DEVELOPMENT ASSESSMENT REPORT

Application No.	DA/2020/0583
Address	314 Liverpool Road ASHFIELD NSW 2131
Proposal	Demolition of existing structures and construction of a residential flat development with basement car parking
Date of Lodgement	24 July 2020
Applicant	Mr Tony Sukkar
Owner	Mr Tony Sukkar Mrs Mouna Sukkar
Number of Submissions	Initial: 12 After Renotification: 2
Value of works	\$11,511,060.00
Reason for determination at Planning Panel	Contentious Development – Over 10 submissions received
Main Issues	Impact on streetscape, unit amenity, site isolation
Recommendation	Refusal
Attachment A	Reasons for refusal
Attachment B	Plans of proposed development
Attachment C	Clause 4.6 Exception to Development Standards
Attachment D	Conditions

Figure 4 – Zoning Map, with subject site identified by black dotted line and isolated sites identified by red dotted box.

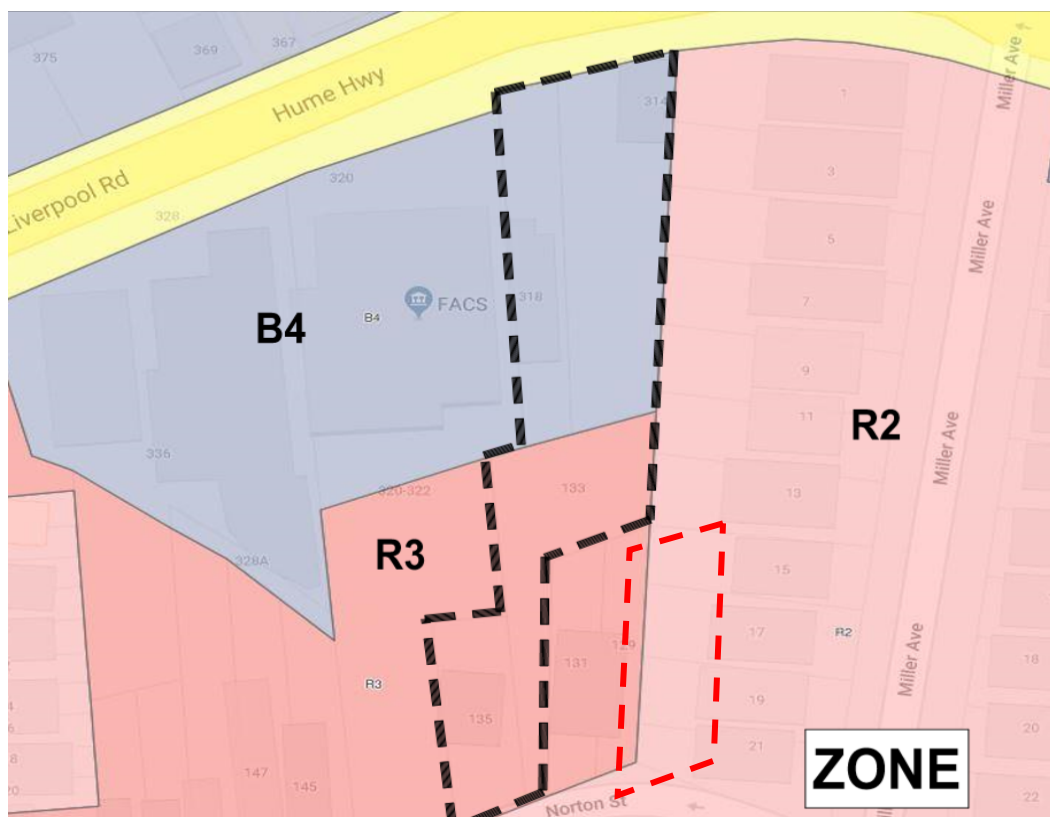
The current development is considered to result in the isolation of Nos. 129 and 131 Norton Street (seen below in figure 4) and is the driving factor for the poor amenity outcomes for the proposed Building B.

The consolidation of the lots would enable a proposal that would likely achieve a significant improvement to the amenity of Building B, be able to accommodate a larger basement to assist with waste management, access and servicing; thereby improving amenity and provide a clear separate though site link for residents pedestrian movements to either Norton Street or Liverpool Road. The lot consolidation would also result in a widened site frontage, allowing a more flexible and efficient approach to the scale, bulk and design of the development on Norton Street.

Figure 5 – Isolation Schematics provided by the applicant

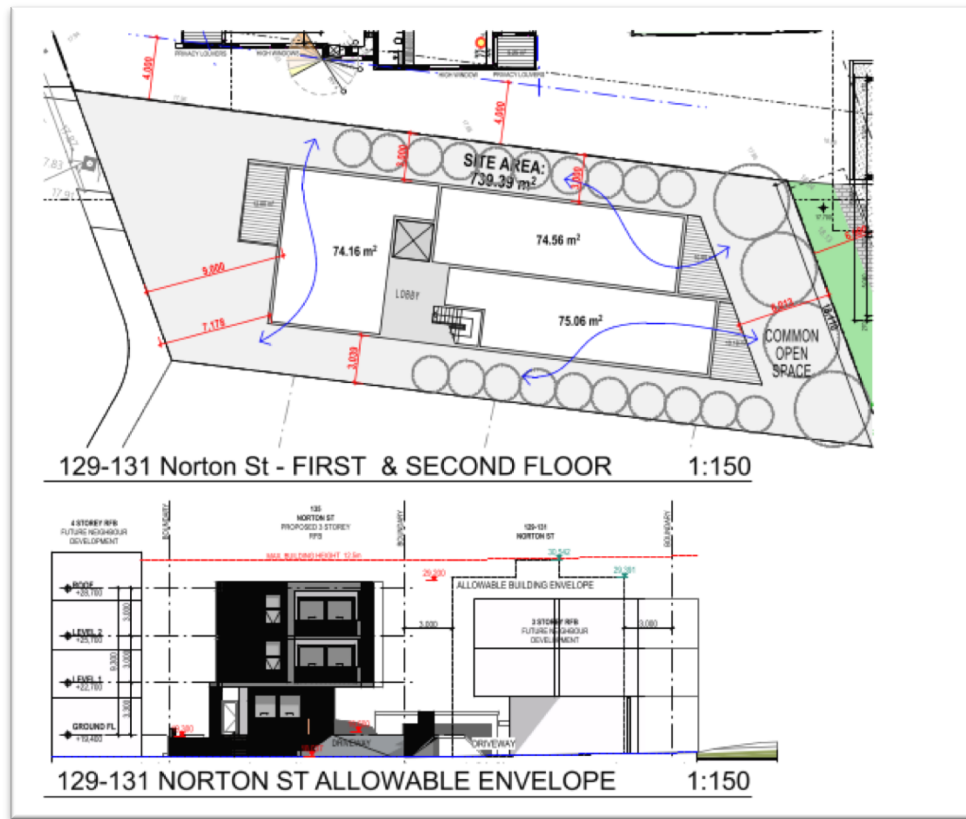
The applicant has provided a schematic design of how the isolated site may be developed should amalgamation not occur (replicated in figure 5 below). These schematics confirm that the isolated site and subsequent development would result in a poor amenity outcome for

occupants/neighbours and is highly likely to detrimentally impact the Miller Avenue Conservation Area.

The proposed isolated lot is expected to be developed with a three (3) storey RFB on 3m side boundary setbacks, similar to that currently proposed by Building B. This would not accord with the ADG building separation requirement on either property. Acceptance of such setbacks would force the subject development to accommodate only highlight windows or reduced glazing to ensure privacy, which would significantly impact the amenity of future occupants.

Overall it is considered that the provided schematics for 129 – 131 Norton Street do not detail a development which would allow for the orderly and economic development of the isolated site. Instead the provided schematics detail the significant and lasting amenity impacts which result to the locality should site amalgamation not occur. The applicant has not satisfactorily demonstrated, in accordance with the planning principle, that site amalgamation is not

Figure 6 – Site Specific Built Form outlined in DCP, subject site highlighted by red dashes

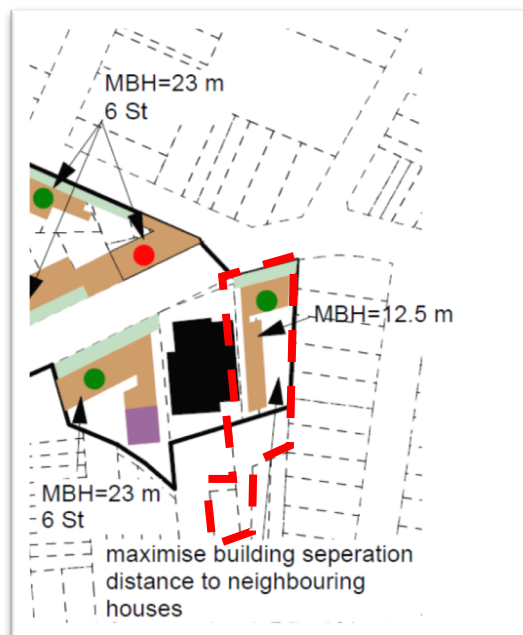
The proposed 3m western boundary setbacks and built form is directly resultant from the proposal’s compliance with a site specific DCP built form control found within Chapter D – Precinct Guidelines of the Inner West Comprehensive DCP 2016. This site-specific built form requirement is replicated within figure 6 below and was created to ensure that any development upon the subject site maximises separation distances to neighbouring houses within the Miller Ave HCA.

In response to the reduced 3m western boundary setback the applicant has appropriately designed the western elevation to incorporate reduced glazing/window openings and POS. Where window openings are proposed they generally incorporate a high windowsill of 1.65m above the proposed finished floor level or have been treated by frosted glazing. Likewise, where the development does propose POS for units these spaces incorporate privacy screen treatments to avoid direct sightlines into neighbouring sites. The development proposes a maximum height of 11.6m (where it relates to lift over runs and common stairs) along the western boundary, with the majority of the building having a maximum height of 10.5m. This proposed building height is combined with the proposed 3m setback will assist to reduce impacts of visual bulk to the neighbouring site at 320 Liverpool Road.

As part of the current plans submitted to Council the applicant has provided a rough schematic of how the neighbouring 320 Liverpool Road could re-develop. This schematic details the neighbouring site incorporating a 6m setback along their eastern boundary (subject sites western boundary) and details a sufficient built form separation to allow for privacy and amenity to all parties. Overall it is considered that the currently proposed western setback is acceptable in its current form and has been designed to achieve a reasonable level of external and internal visual privacy.
